RE: **The Point Phases 11-13 Construction Drawings**
Case Number: CD 22-05
Response to 2nd Construction Drawing Review Comments
AWH-20000

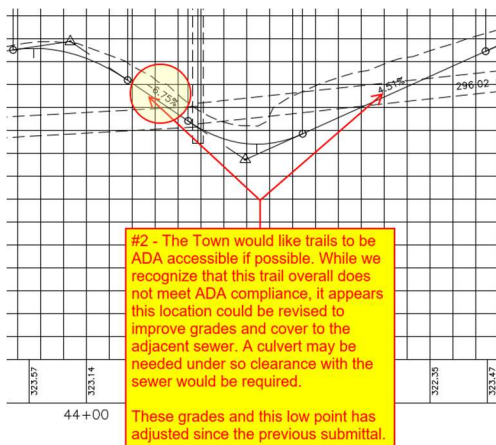
1. Please submit a revised storm package for review.
 - a. Please include a 10-year storm design for all storm sewer and a 25-year design for culverts.

McAdams Response: The storm drainage calculations are included with this re-submittal as requested. Culvert design calculations are included with the Stormwater Control Measure calculations and are included with this re-submittal also.

Sheet C5.07 – Plan and Profile

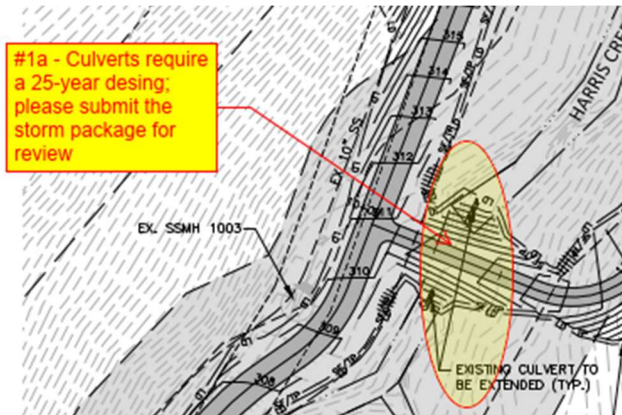
2. The grades of the trail have changed since the last submittal; Please consider adjust the trail to improve grades and cover over the adjacent pipe.

3.

McAdams Response: As discussed at the first TRC meeting, the greenway alignment and grading is very sensitive to the existing conditions. We have positioned the horizontal and vertical alignments with great care to minimize the impacts of the steep slopes on both sides of the greenway. At this location, there is a shear stone wall or outcropping immediately adjacent to the trail on one side and a steep slope to Harris Creek on the other. We understand looking at the profile, it seems we could just fill this area in and everything would work better, but please understand any fill here would cause the need for a retaining wall on the creek side of the trail and it would impact the stone face on the other side. We believe this is the best design to minimize impacts to the surrounding area. Also understand, the profiled alignment is at the center of the trail and proposed grades are higher at the SS pipe and manhole than is shown here.

McAdams Response: Same as comment #2 above.

Sheet C9.07 – Stormwater Control Measure ‘N’ Landscape Plan

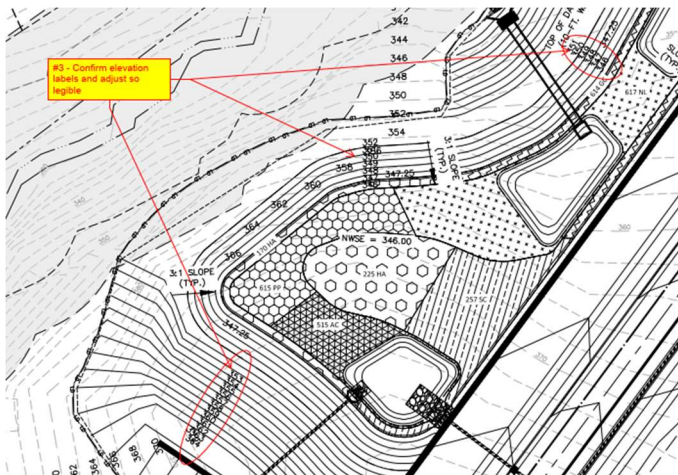
5. Please confirm the elevation labels are aligned with the correct contours around the stormwater measure.

McAdams Response: The elevation labels around SCM N have been revised to align with the correct contours.
